SAFETY EVALUATION BY THE OFFICE OF NUCLEAR REACTOR REGULATION

RELATING TO THE MODIFICATION OF THE SPENT FUEL POOL

FORT CALHOUN STATION, UNIT NO. 1

DOCKET NO. 50-285

Spent Fuel Pool Region 2 Storage Criteria  
 Minimum Required Fuel Assembly Exposure  
 as a Function of Initial Enrichment  
 to Permit Storage in Region 2

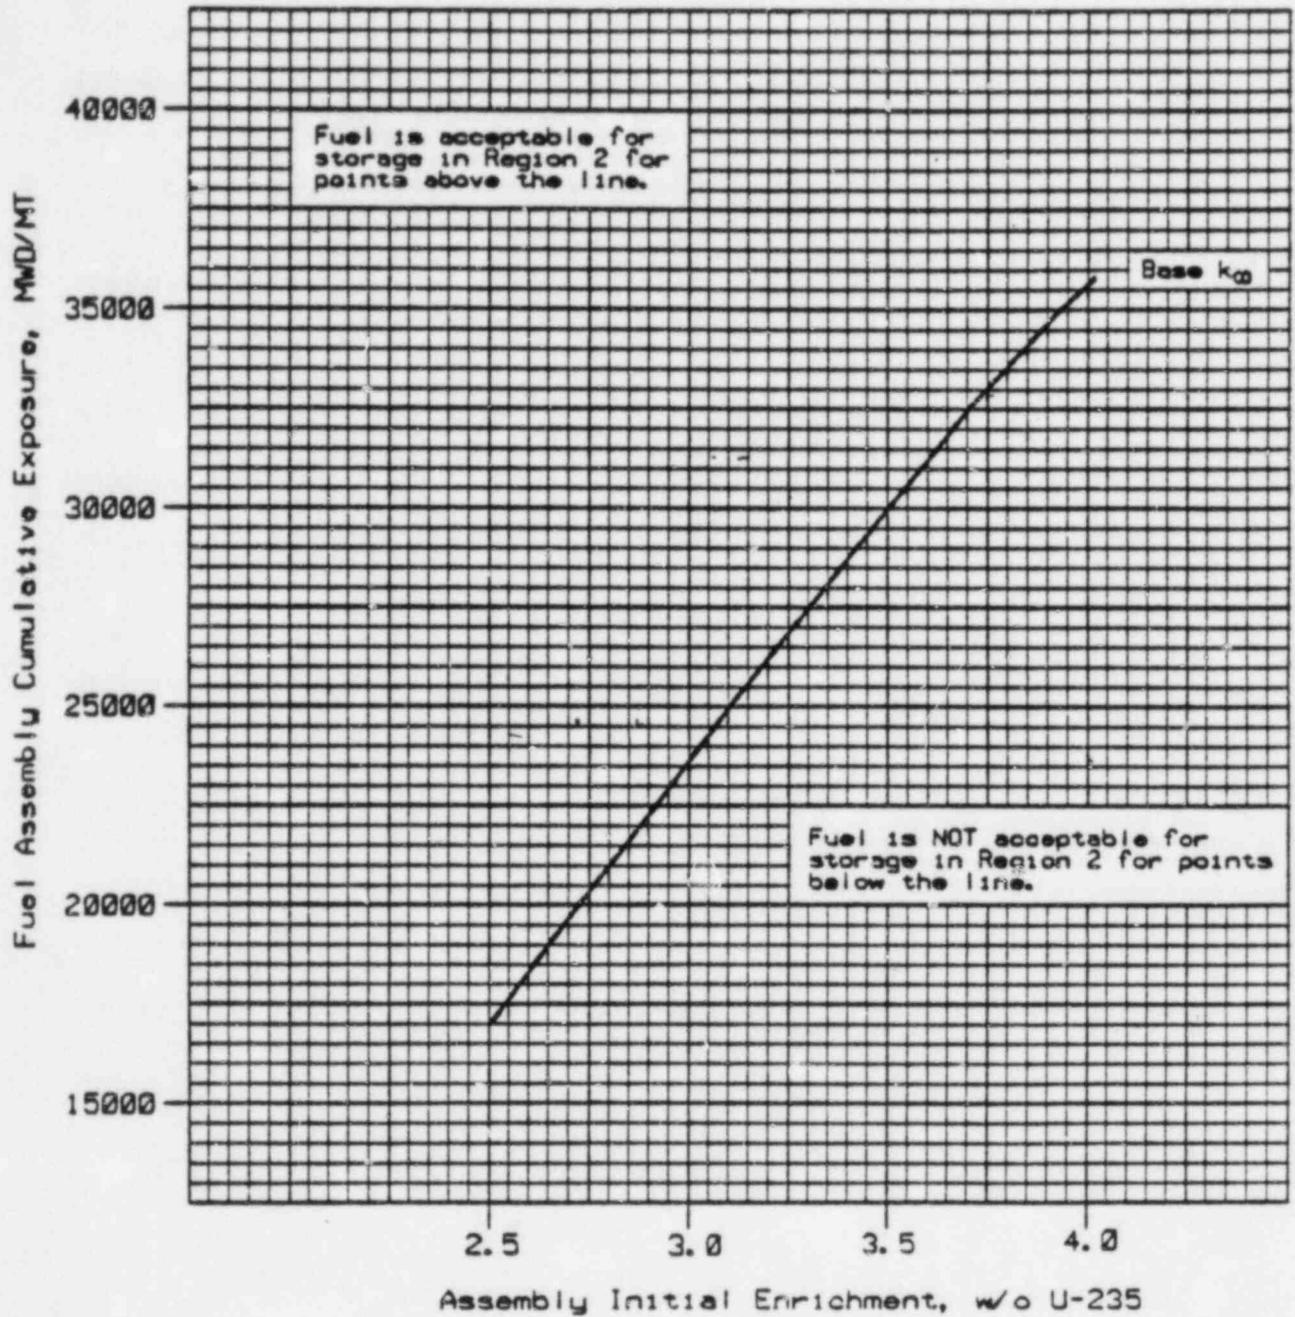
In order to establish burnup criteria for storage in Region 2, the infinite multiplication factor (at a pool temperature of 68°F with minimum post-shutdown fission product inventory) of a fuel assembly as a function of burnup is obtained for a number of initial enrichments. The multiplication factor of the storage racks is next calculated as a function of the infinite multiplication factor of the stored assemblies for the various initial

enrichments. The assembly infinite multiplication factor which produces a rack multiplication factor of 0.91 is obtained from these curves as a function of initial enrichment. This rack multiplication factor is chosen so as to remain below our acceptance criterion of 0.95 when the above uncertainty of .0365 is added. Finally, a curve is drawn of the burnup required to produce a rack multiplication of 0.91 as a function of initial enrichment. This curve, shown in the attached Figure 2-10, is approximately linear and yields required burnups of 17,000 MWD/MTU for a 2.5 weight percent U-235 enrichment and 35,700 MWD/MTU for a 4.0 weight percent U-235 enrichment.

Based on our review, we conclude that any number of CE 14X14 designed fuel assemblies with burnups in the acceptable region of the attached Figure 2-10 may be stored in Region 2 of the Fort Calhoun spent fuel racks.
